**FINDINGS AND RECOMMENDATION  
OFFICE OF PLANNING AND ZONING  
ANNE ARUNDEL COUNTY, MARYLAND**

**CASE NUMBER:** 2025-0137-V

The applicants are requesting a variance to allow a dwelling addition with less setbacks and buffer than required and with disturbance to slopes of 15% or greater<sup>1</sup> on property located at 126 Round Bay Road in Severna Park.

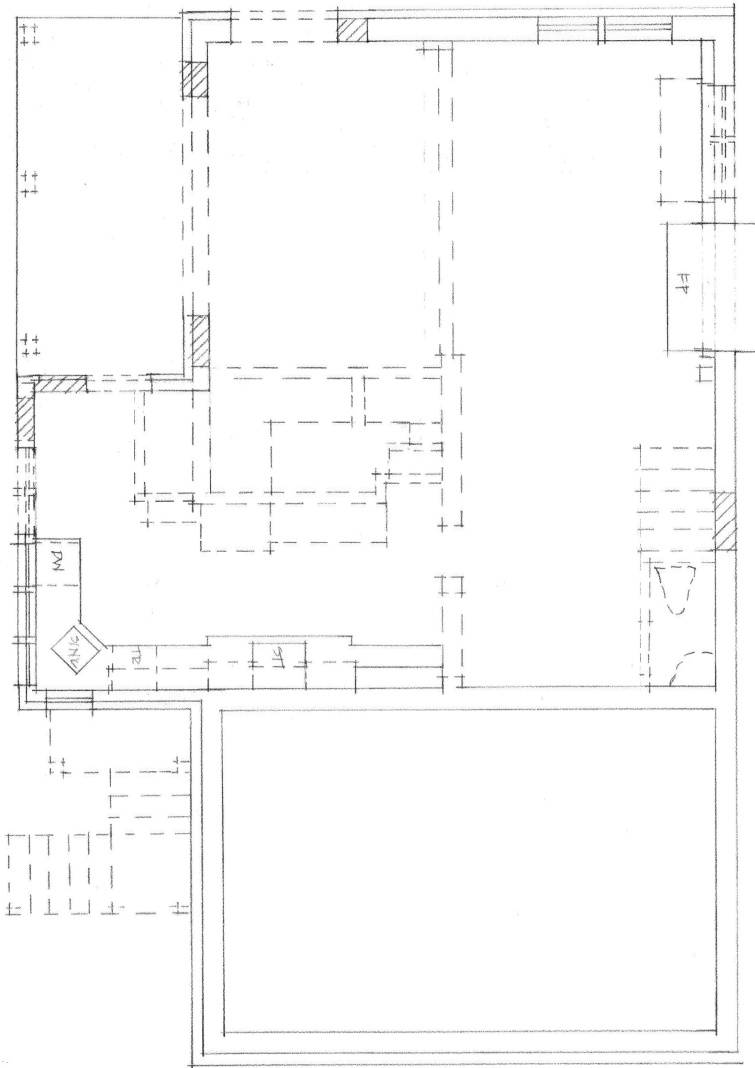
this case, steep slopes are present along the western side and rear of the property, totaling approximately 23% of the site, which limits the developable area of the lot to some degree. However, there is opportunity to redesign in a manner that would minimize the slope disturbance.

The applicants' letter explains that the three-story addition with basement is sited narrower than the existing [nonconforming] dwelling to comply with the side yard setback. However, this Office notes that setback variances are preferred over critical area variances and questions why a wider addition was not proposed along with a setback variance request to keep the addition in line with the existing dwelling. In fact, were it not for the proposed 8' by 23' front porch, it appears that the addition could have been rotated 90 degrees to eliminate most if not all of the permanent slope disturbance, resulting in only temporary disturbance necessary for access during construction.

The proposed addition is quite large. With a footprint of 684 square feet and with four levels (three stories plus a basement), the existing living space will more than double in size. While the applicants point to functional reasons for justification of the proposed improvement locations and associated variance, it still appears that a different footprint and alternative layouts could have been designed that could have eliminated the permanent slope disturbance and minimized the amount of temporary disturbance necessary. If nothing else, because there is already an entry porch proposed on the eastern side, the 8' by 23' front porch could be eliminated, which would significantly reduce the proposed slope disturbance. As such, the requested variance is not considered to be the minimum necessary to afford relief.
